**According to UL and the NFCA (National Fireproofing Contractors Association):
The flutes above the beam flange being sprayed is required to be full with spray fireproofing...**

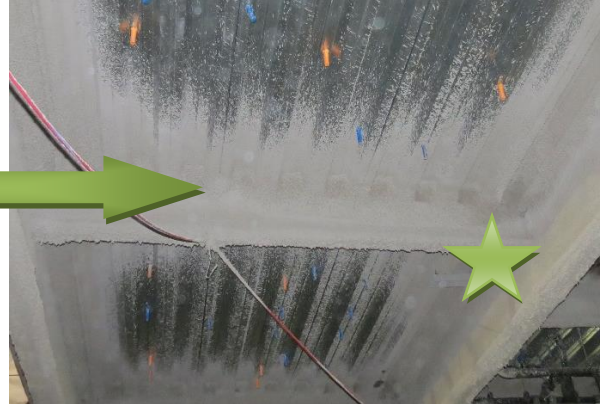
The flutes perpendicular to the top flange of the beam is required to be fully packed with spray fireproofing to the edge of the beam flange or other approved methods per NFCA Bulletin 1003.

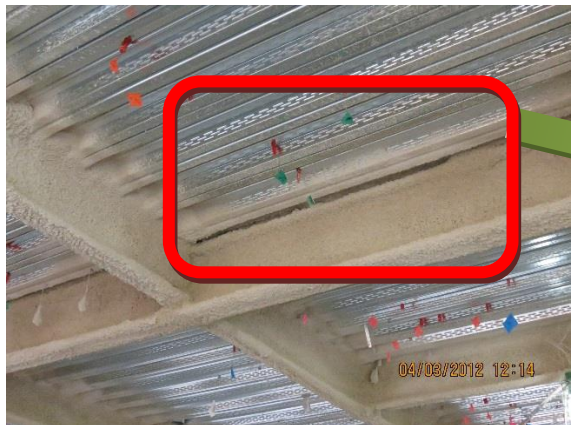
The floor should be covered with plastic in order to protect the floor from extra moisture from the spray fireproofing, which could create concerns with the floor finish.

The flutes parallel to the top flange of the beam is required to be fully packed with spray fireproofing to the edge of the beam flange or other approved methods per NFCA Bulletin 1003.
